70266_02

UWTSD Library

First Floor Plan

UWTSD-STL-04-01-DR-A-ZZZZ-11D02 C119

① First Floor Plan
1:100

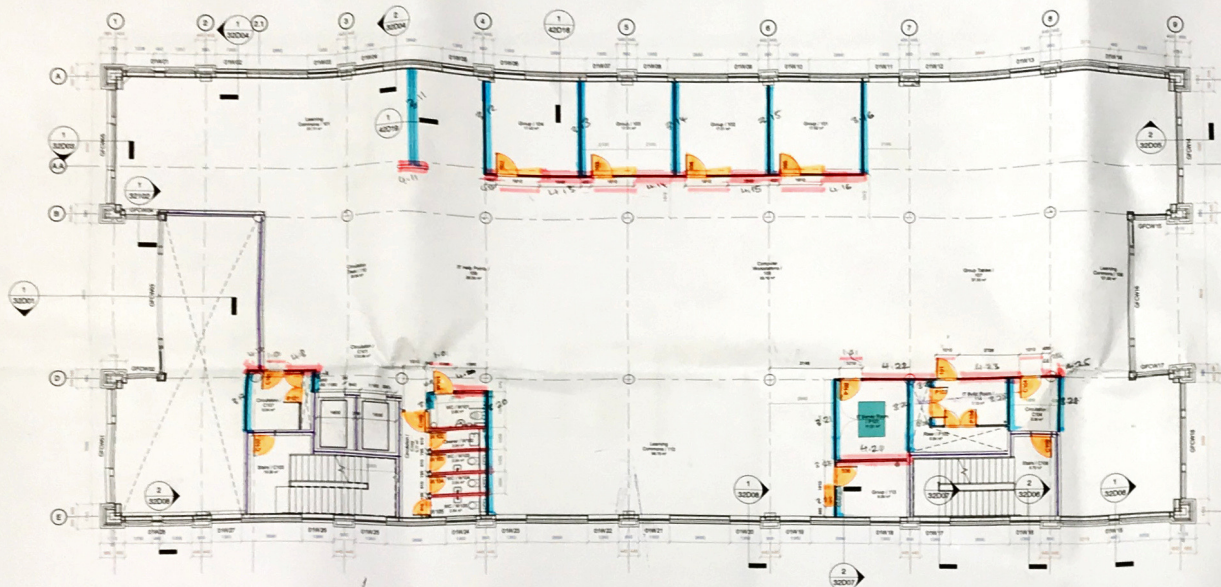
$$\begin{array}{r} 4194 \\ \times 55 \\ \hline 20970 \\ 230580 \\ \hline 230580 \\ 20970 \\ \hline 2328770 \end{array}$$

211 = 4.3m	4.11
212 = 4.2m	4.12
215 = 4.2m	4.13
214 = 4.2m	4.14
215 = 4.2m	4.15
216 = 4.2m	4.16
212 = 2.8m	4.17
218 = 1.0m	4.18
210 = 0.70m	4.19
220 = 0.50m	4.20
221 = 0.5m	4.21
222 = 0.15m	4.22
223 = 0.28m	4.23
224 = 0.30m	4.24
225 = 0.30m	4.25
226 = 0.20m	4.26
227 = 2.50m	4.27
223 = 2.40m	4.28

$4.11 = 1.20$
 $4.12 = 0.50$
 $4.13 = 2.20$
 $4.14 = 2.20$
 $4.15 = 2.20$
 $4.16 = 1.00$
 $4.17 = 0.90$
 $4.18 = 1.00$
 $4.19 = 0.80$
 $4.20 = 1.50$
 $4.21 = 3.20$
 $4.22 = 2.30$
 $4.23 = 2.20$
 $4.24 = 0.20$
 $4.25 = 0.20$

264
426 = 260m
427 = 260m
428 = 260m
429 = 260m
1040m. } we partition

$$\begin{array}{r} 4.20 \\ 7.00 \\ 3.75 \\ 2.60 \\ 2.60 \\ 3.30 \\ 5.20 \\ 2.30 \\ 0.60 \\ 0.60 \\ 2.85 \\ 4.15 \\ 1.10 \\ 2.10 \\ 3.75 \\ \hline 46.10 \\ \times 365 \\ \hline \end{array}$$
